EC70139 REV. 0
ATTACHMENT Z111R0
DWG. NO. 522-041-021

NO.		DESCRIPTION		DRAWN
REVISIONS				
		NUCLEAR ENGINEERING		
		CRYSTAL RIVER UNIT 3		
		AUXILIARY BUILDING - SOUTH STEEL FRAMING MODIFICATIONS DETAILS		
		EWN DRAWN	JGC CHKD.	X APRVD.
C DISCP.	021 SHEET	DWG.	522-041	
				REV.

DETAIL A
SCALE: 1 1/2" = 1'-0"
DWG. S-522-004

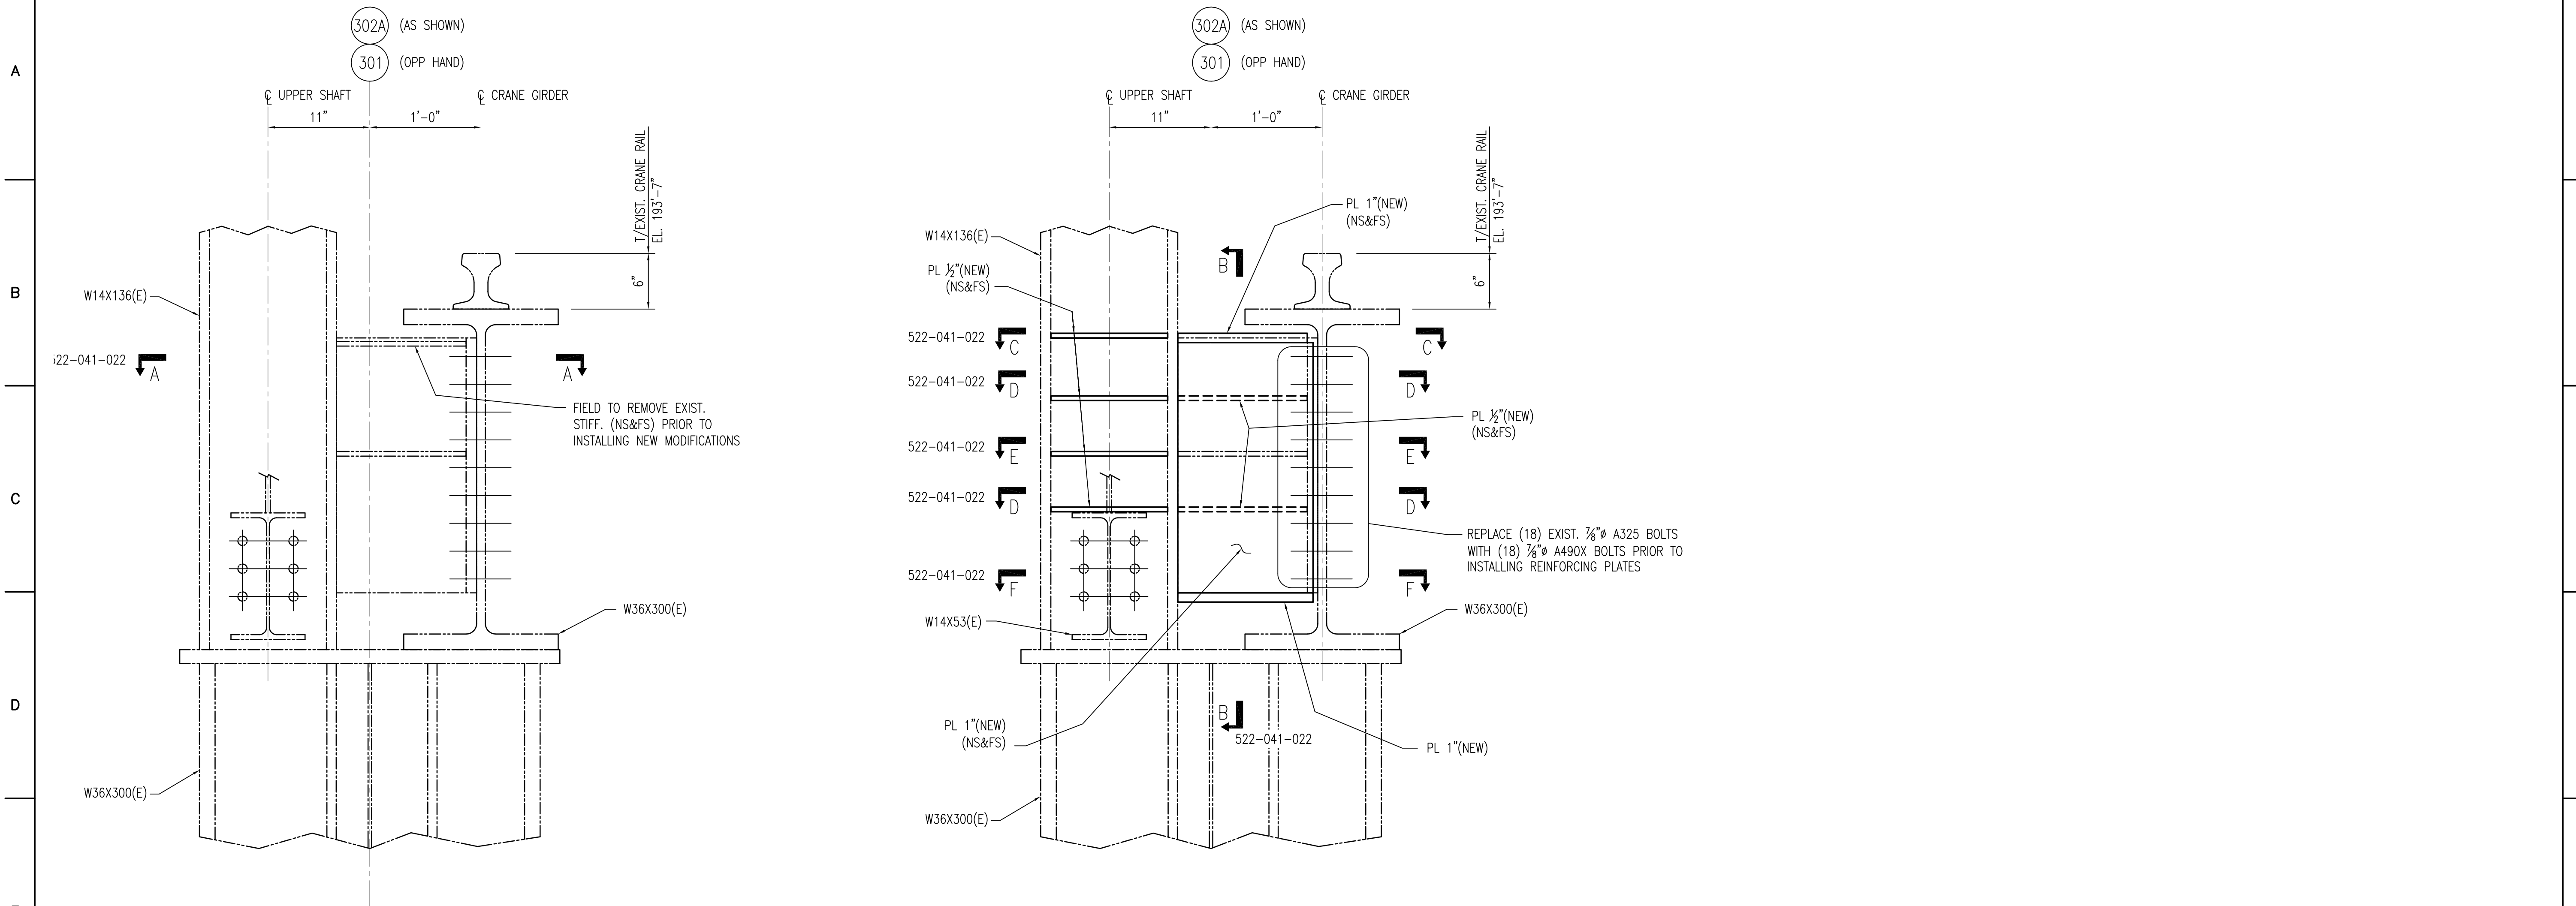
PHASE 1
FIELD TO REMOVE EXIST. MAT'L AS SHOWN & NOTED

PHASE 2
FIELD TO INSTALL NEW MAT'L AS SHOWN & NOTED
